Paterson and Carrington - Site Plan Approval 4034 Centre Road, Bolton's Corners

Project No. 21-D-5883

Attached is a copy of the following drawings and calculations prepared in response to the D.M. Wills Associates comments dated October 4, 2022 and the Otonabee Region Conservation Authority comments dated October 5, 2022 submitted for your information:

DRAINAGE AREA PLAN

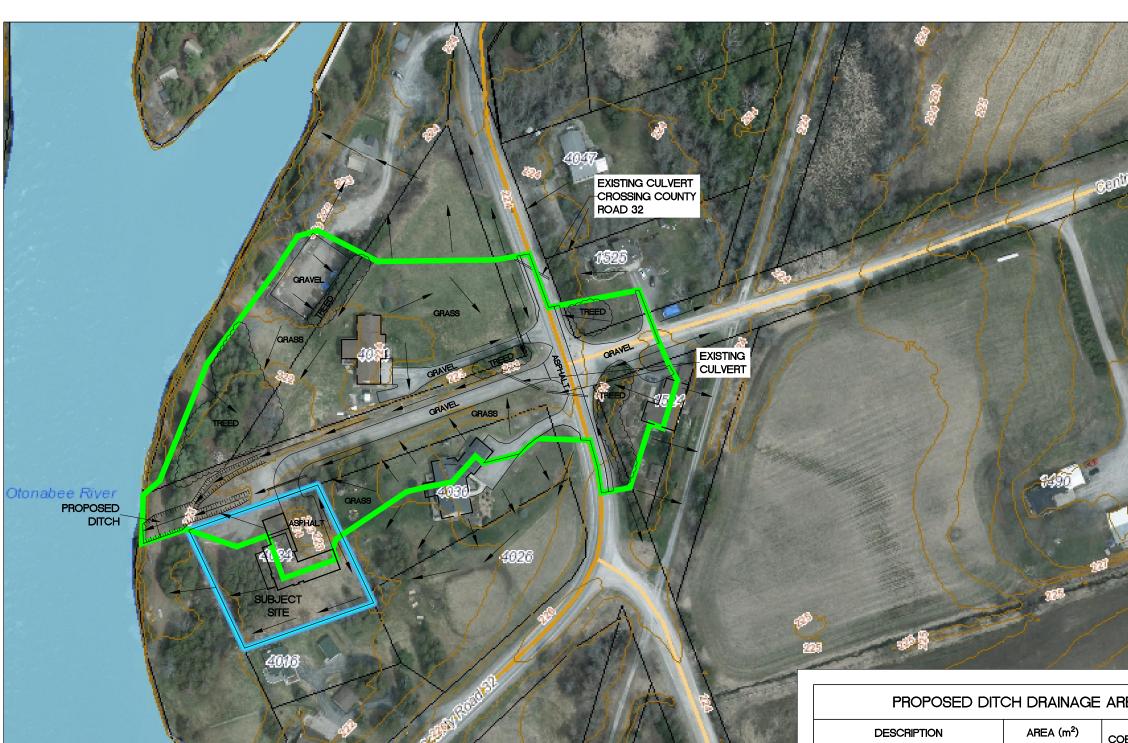
2. Confirm the drainage area and 100-year flow directed to the proposed outfall ditch. A rough sketch and rational method calculations are sufficient to address this comment.

Drainage Area Plan Drawing No. 5883-03 identifies the total catchment area and the landuse of the area flowing into the proposed outfall ditch. The 100-year rational method calculations and the open channel flow calculations attached to this letter indicates that the proposed outfall ditch has sufficient capacity to convey peak stormwater flows in excess of the calculated 100-year flow rates.
